COUNCIL ASSESSMENT REPORT

Panel Reference	PPSSCC-134
DA Number	DA 270/2021/JP
LGA	The Hills Shire Council
Proposed Development	Staged Construction of Four Residential Flat Buildings containing 330 units and Retail Floor Space.
Street Address	Lot 5 DP 30916 Commercial Road, Rouse Hill
Applicant	Universal Property Group Pty Ltd T/As The Bathla Group
Consultants	John M Daly & Assoc. Pty Ltd – Surveyor Calibre Professional Services Pty Ltd – Town Planner Kannfinch Group Pty Ltd – Architect Orion Consulting – Civil Engineers Varga Traffic Planning Pty Ltd – Traffic & Parking Assessment Report Conzept Landscape Architects – Landscape Plans Redgum Horticultural – Arborist Report Ergon Consulting – Access Report Pulse Acoustic Consultancy – Acoustic Report ACE Structural Services Pty Ltd – Structural Engineers Report SLR Consulting – Qualitative Wind Assessment, Natural Ventilation Assessment & Solar Access Report Ochre Environmental Management – Dust Management Plan Cumberland Ecology – Flora and Fauna Assessment Geotesta Pty Ltd – Contamination Site Investigation Report Auswide Consulting – Waste Management Plan Mosman Certifiers – BCA Report Dominic Steele Consulting Archaeology – Abor

Ground Floor – Building A – Unit G04
(unroofed terrace area of non-compliance highlighted in yellow)

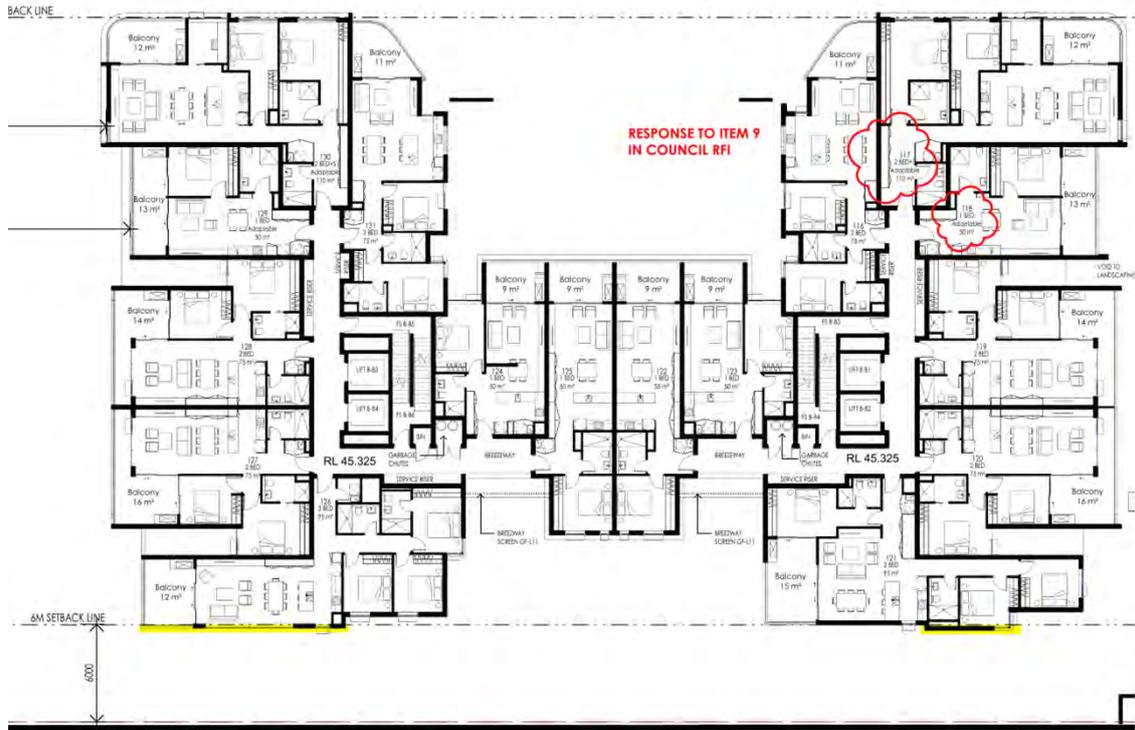
Buildings A and B have a minor encroachment into the 6m rear western side setback. This encroachment is very minor in nature being a maximum of 350mm of the external wall and roofing.

Full compliance with the setback control is not achievable as it would result in non-compliance of the ADG internal unit dimensions. The minor setback encroachment does not impact on the amenity of the neighbouring properties. The objectives of the control are still met.

Considering the nature of the development, this encroachment is seen to be insignificant. The proposed development complies with all the other setbacks and is consistent with the objectives of Clause 3.3 of THDCP – Part D Section 5. The proposed encroachment does not impact on the provision of a useable area of private open space, ability to provide sufficient space for vehicle parking, sunlight access to habitable rooms.

It is considered that these encroachments are minor in nature and add to the architectural diversity of the building.

Ground Floor – Building B – Unit G09
(unroofed terrace area of non-compliance highlighted in yellow)

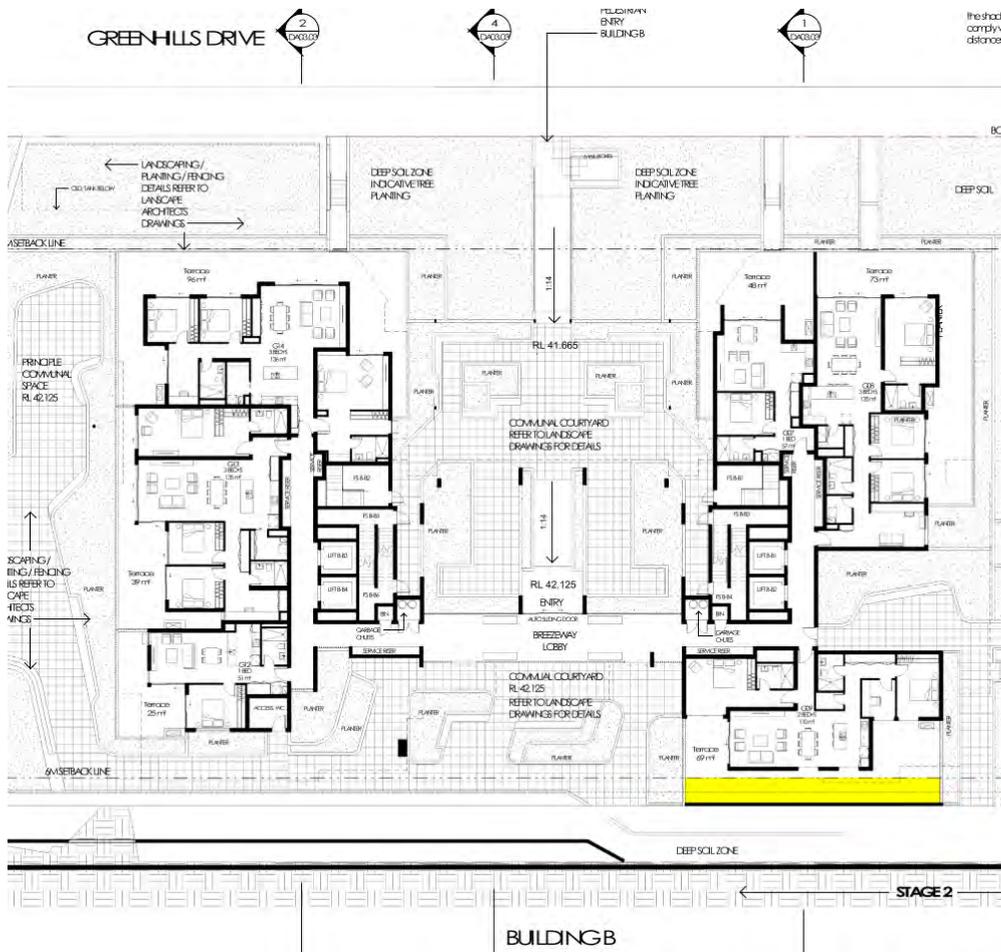
Building B proposes a set back of 5.65 metres to the western boundary and approximately 4.2 metres to the unroofed terrace of one ground floor unit (Unit G09) only. The areas of non-compliance are highlighted in yellow below:
